虛社客訴畫面異常抖動

訊號阻抗過大

加熱前

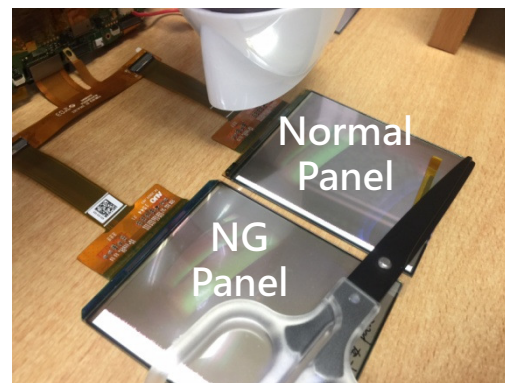
- 透過兩種方式可以現象，但原理相同，就是加大訊號的阻抗

1. 正常panel在 虛社平台加熱

Issue

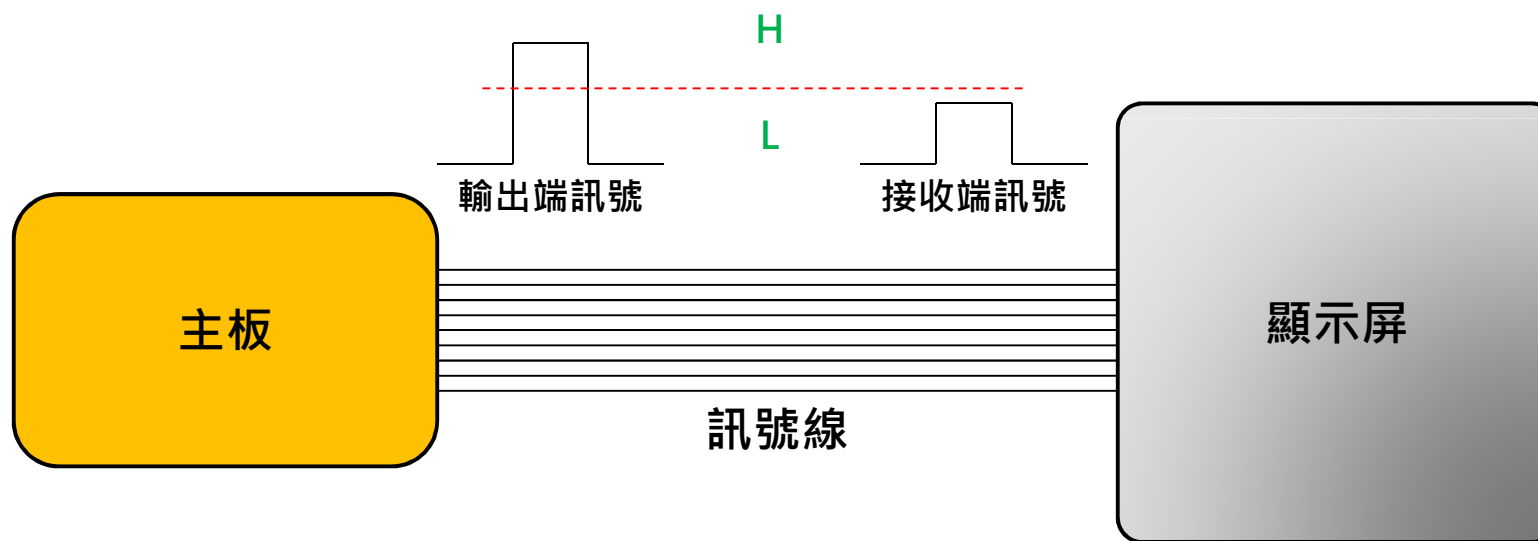
- 如下圖，在主板到顯示屏的訊號線阻抗若是過高，訊號振幅會下降，顯示屏有機會解錯訊號，造成顯示雜訊的產生(畫面抖動現象)
- 懷疑是因為訊號路徑因外力受損造成此現象

High-Speed Receiver Specification

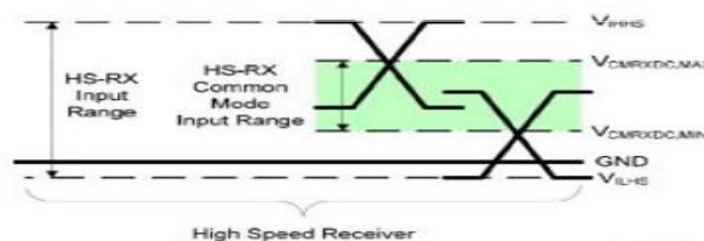
- NG panel在AUO系統上並不會有畫面異常的現象，所以客戶的系平台打出來的
- MIPI訊號swing可能不滿足規格(如下圖，需大於70mV)，這部分也請客戶double-check，是否在接到
- panel FPC前的MIPI訊號swing就已經 $< 70\text{mV}$ ？
